Demolition of all existing structures on the site, and construction of a nine level (including ground and mezzanine car park level) residential flat building with ancillary car parking and landscaping.

278 South Terrace, Adelaide

020/A015/19

OVERVIEW

FIGURE 3 - FIRST FLOOR

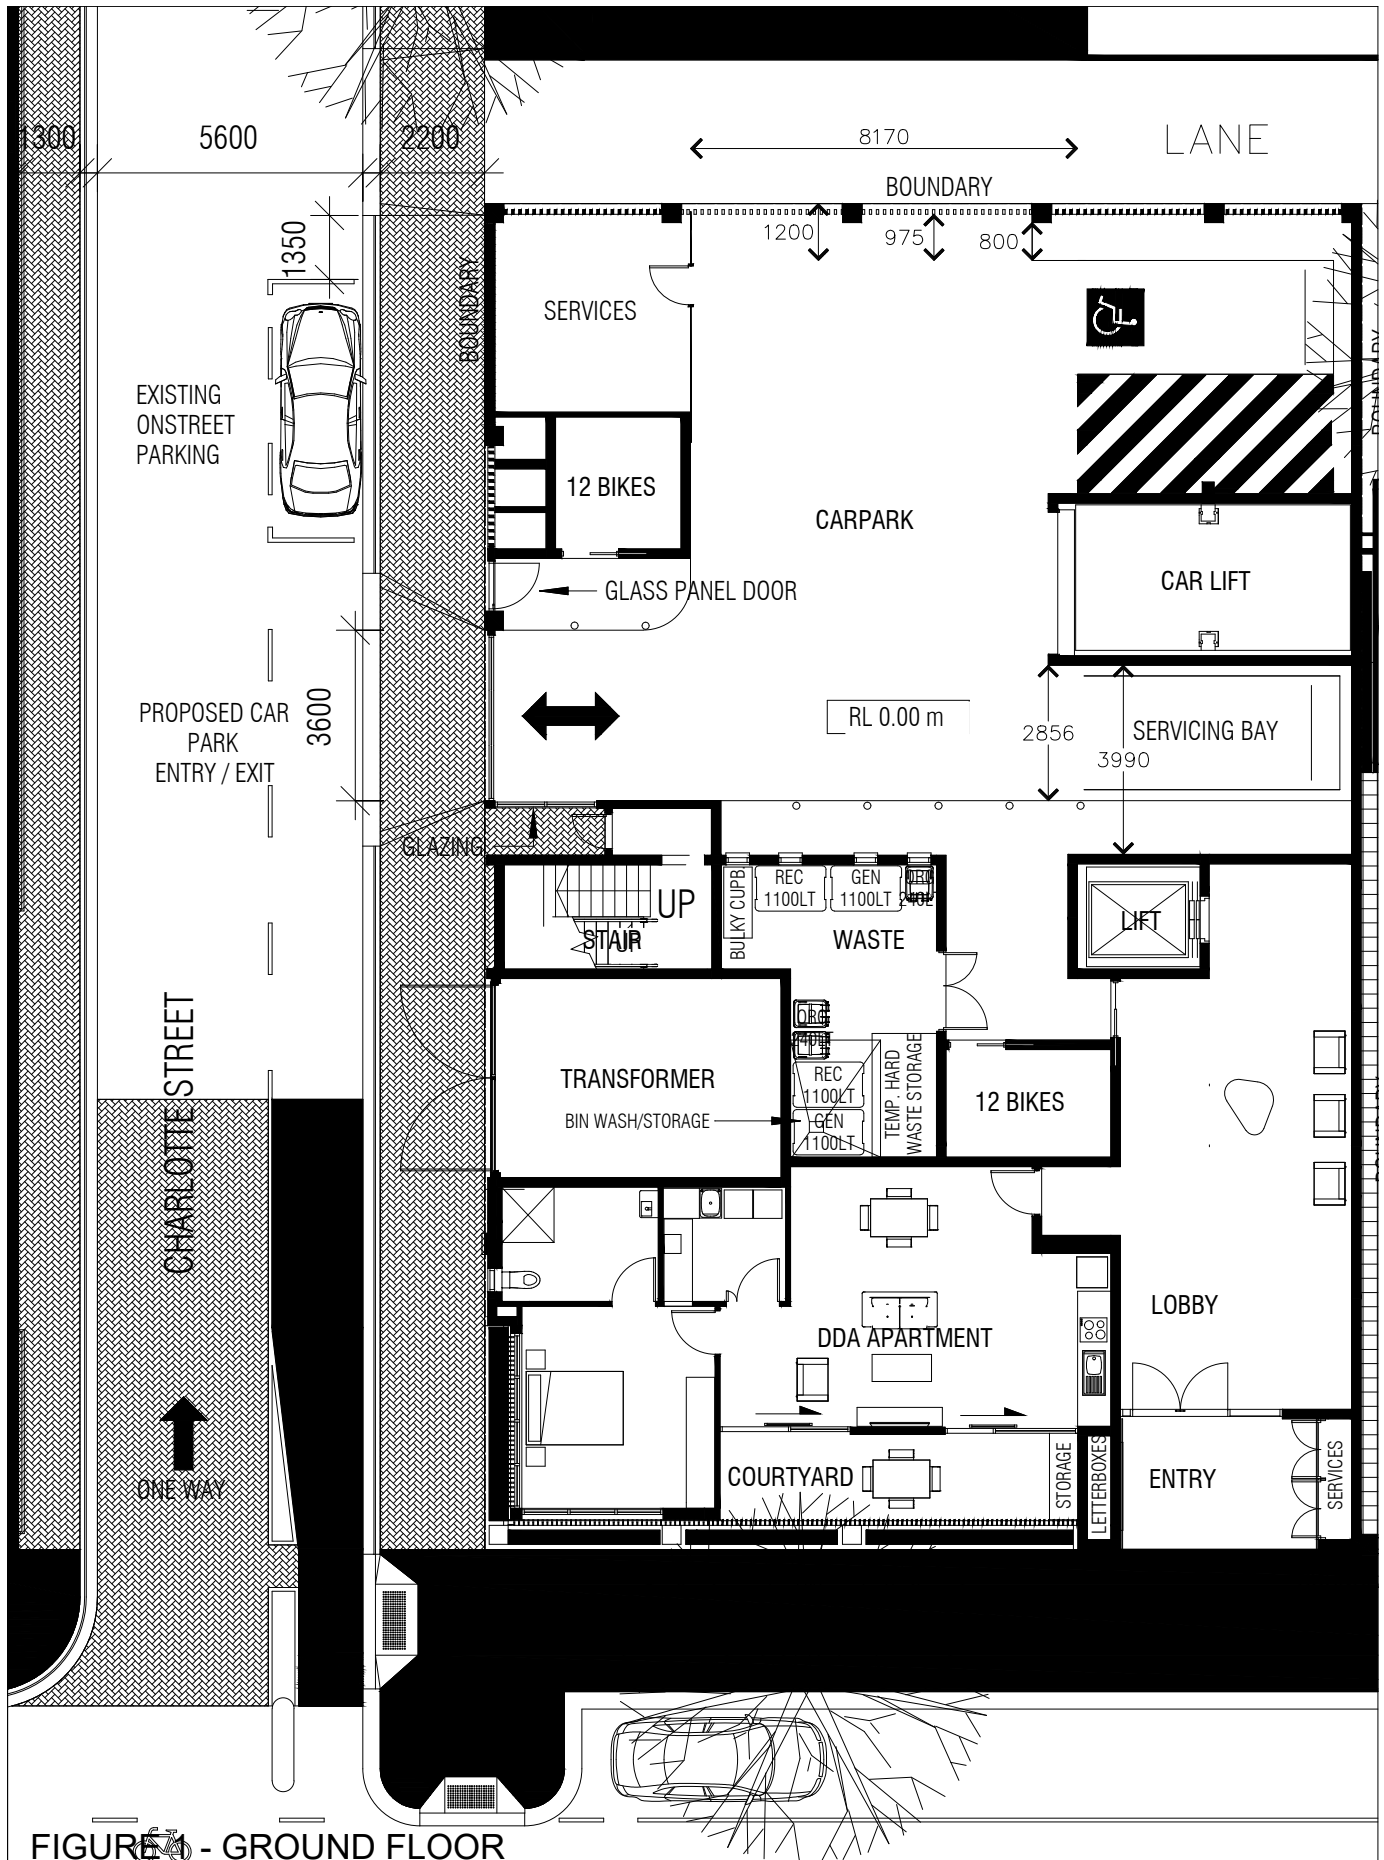
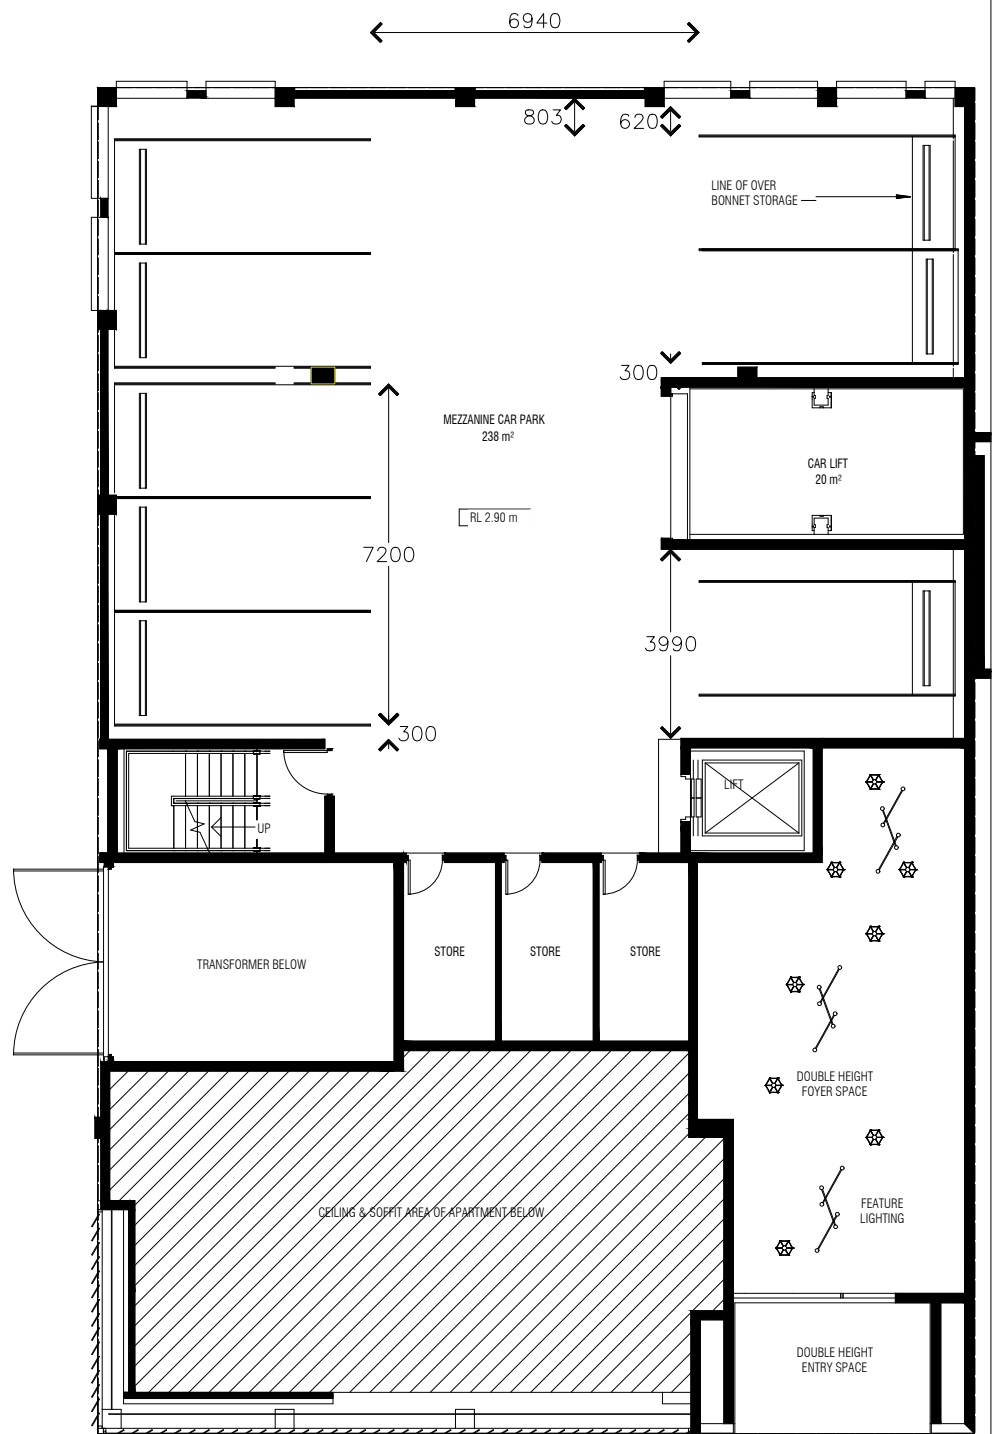
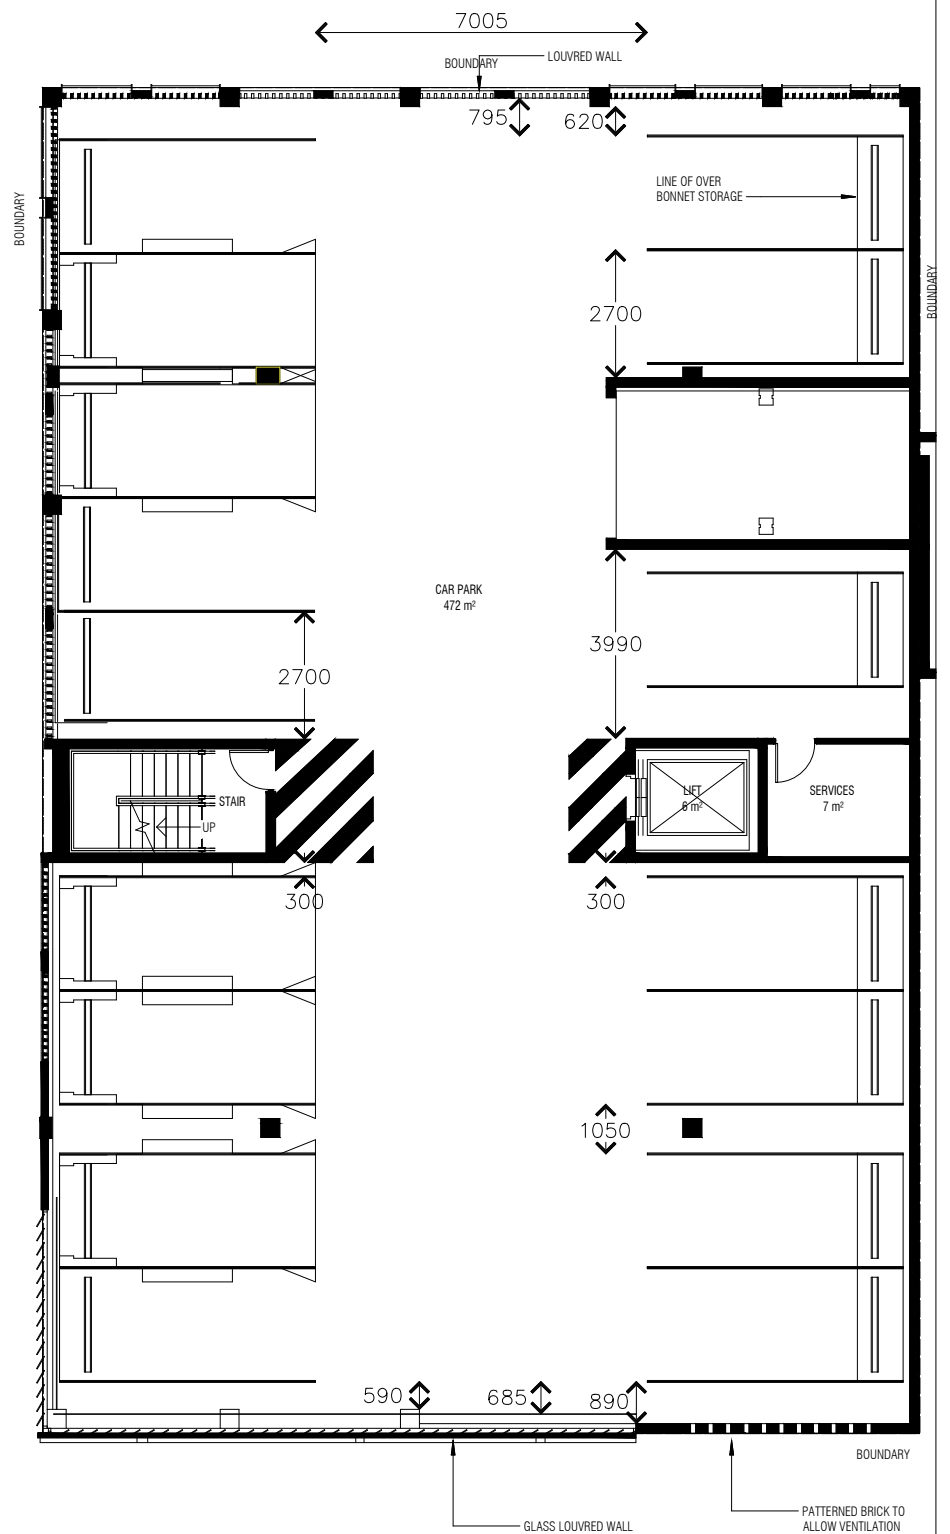
- *Sight distance in accordance with figure 3.3 of AS2890.1:2004 to be provided at the entry point and abutting lane.*
- *The waiting bay for the car lift is to be clearly delineated and must not be allocated to residential parking.*

The attached concept designs would alleviate Council's concerns, noting that example door opening design envelopes have been shown in *Figure 3 (First Floor)* in red identifying that appropriate clearances would be satisfied.
